ADDENDUM NO. 01

ELOP Year Two Track Upgrades

PROJECT NAME: Thomas Jefferson MS – ELOP Year Two

DARDEN PROJECT NO. 2468.2

A
SD/L103
EXISTING PUMP YARD AND CONTROL WIRE EXTENSION
SCALE: 1" = 20'

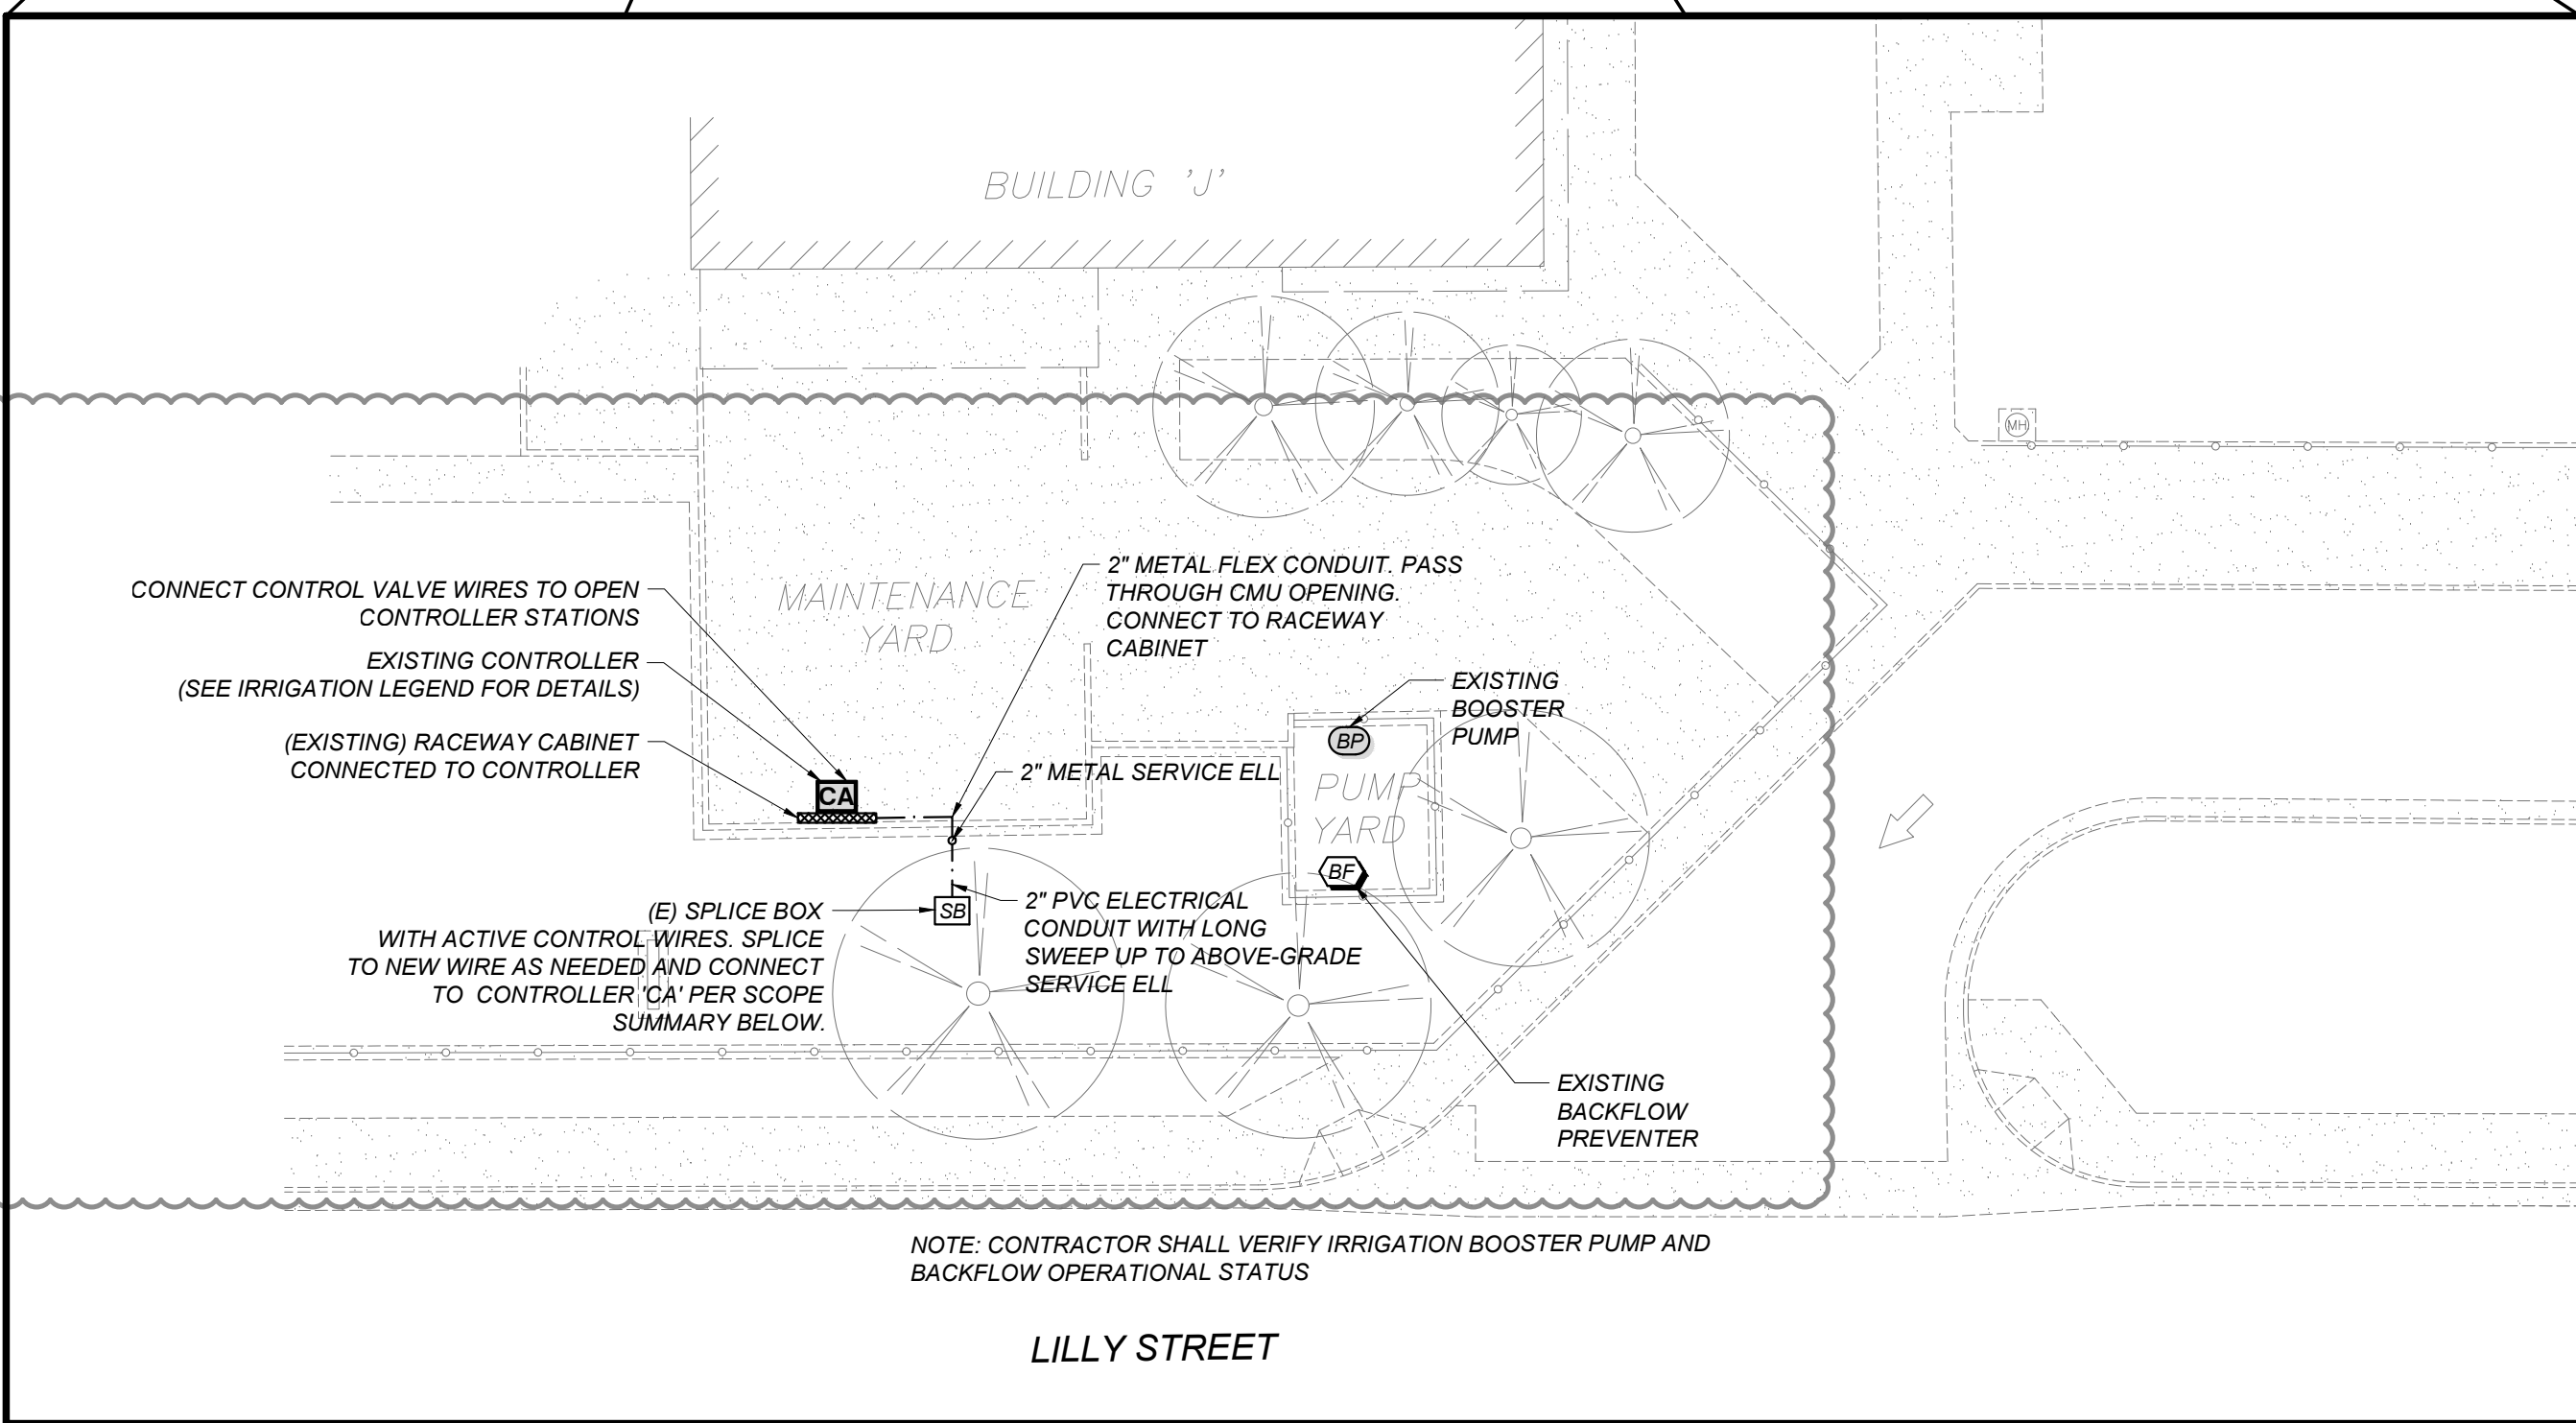
AD1-L02 Refer to Sheet SD/L104, IRRIGATION DETAILS:

1. Detail G has been revised.

BIDDING ADDENDUM 01 STORM DRAIN SCOPE:

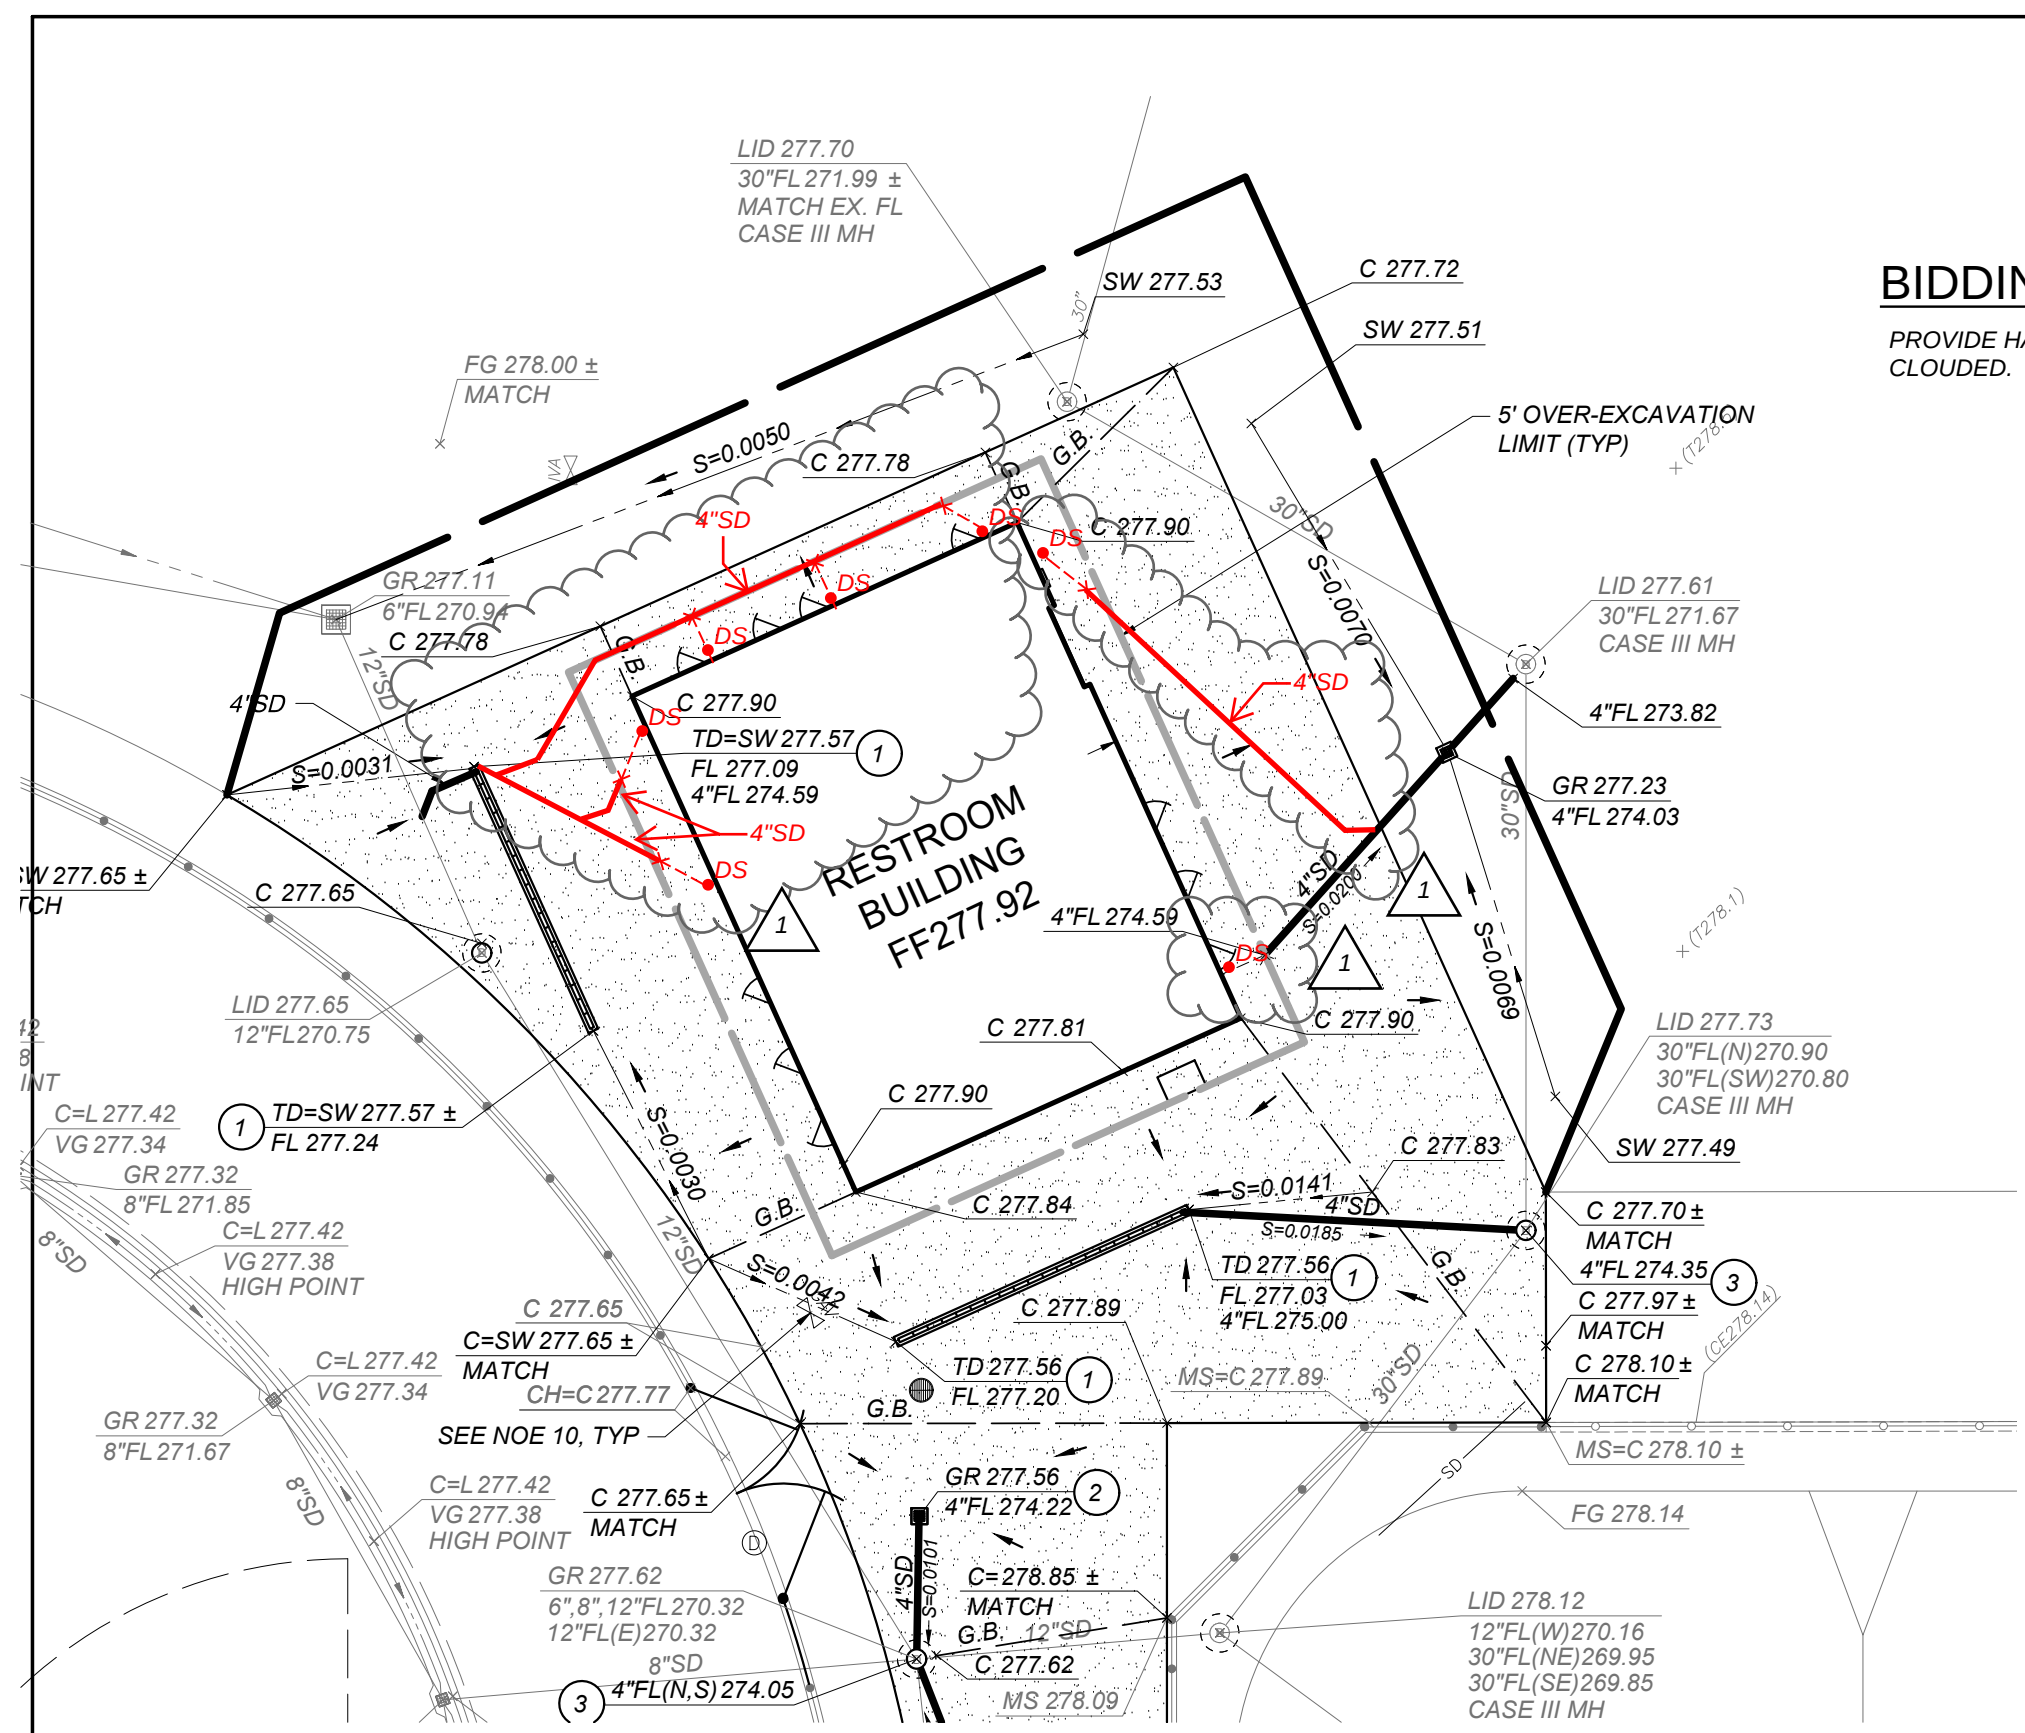
AD1-C01 Refer to Sheet SD/C402, PARTIAL GRADING AND DRAINAGE PLAN:

1. Connect all downspouts to the storm drain system as indicated on the Partial Grading and Drainage Plan (Sheet AD1-CX01).

PROVIDE HARD-PIPED CONNECTIONS TO BUILDING DOWNSPOUTS AS SHOWN AND CLOUDED.
